Staff Analysis of M. Niels Engineering Report, submitted with IBEW Lighting Alteration Comments.

Executive Summary:

Figure 2. Average Realization Rate by Measure for Energy Savings

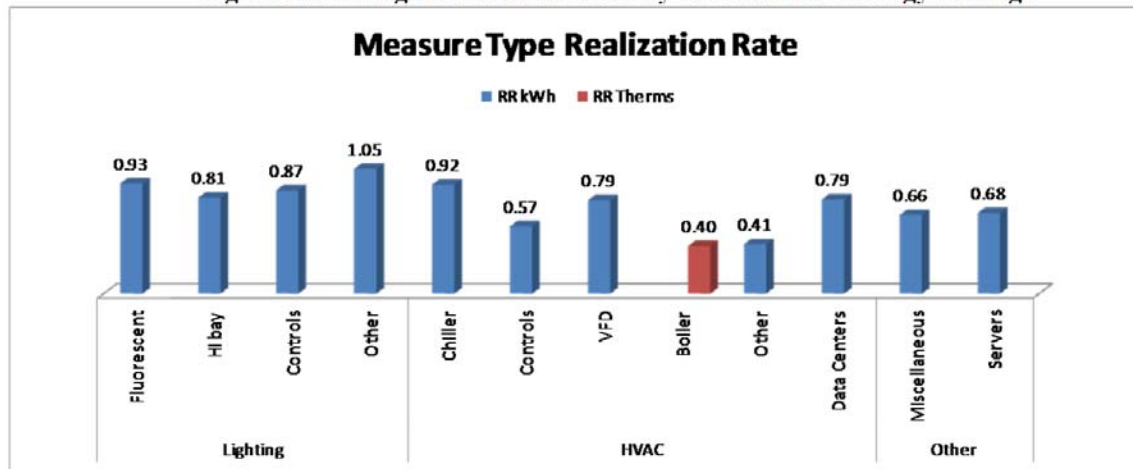
The report by Lutz and Tirumalashett supports the need for an exception from acceptance testing for small projects. Figure 2, copied here, indicates that lighting controls have a realization rate of 87% without acceptance testing. This means that actual savings were falling short of estimated savings by only 13% (or less than 1/6th of estimated savings). 13% can be substantial in a larger project, but will not be cost effective for small projects with high fixed overhead.
